# Manual Supplement

Manual Title: 830 Users  
USB Number: 4473175  
Print Date: July 2014  
Revision/Date:

Supplement Issue: **2**  
Issue Date: 1/16  
Page Count: 3

**Figure 4-4. Parts of sensor**

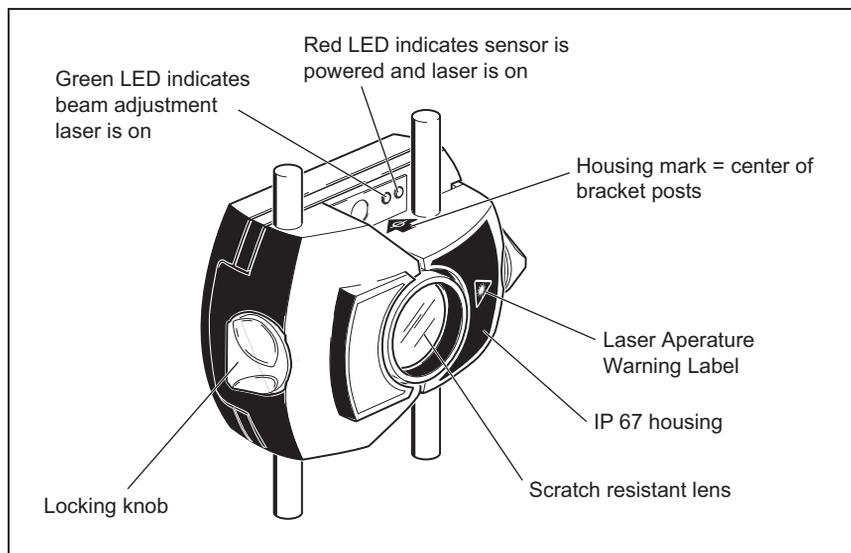
On page 19, replace **Figure 4-4**, and add the following **Caution**:

### ⚠ Caution

**To prevent damage to the sensor, do not drop. The sensor requires recalibration from service center if dropped. A faulty sensor significantly affects the diagnostic accuracy.**
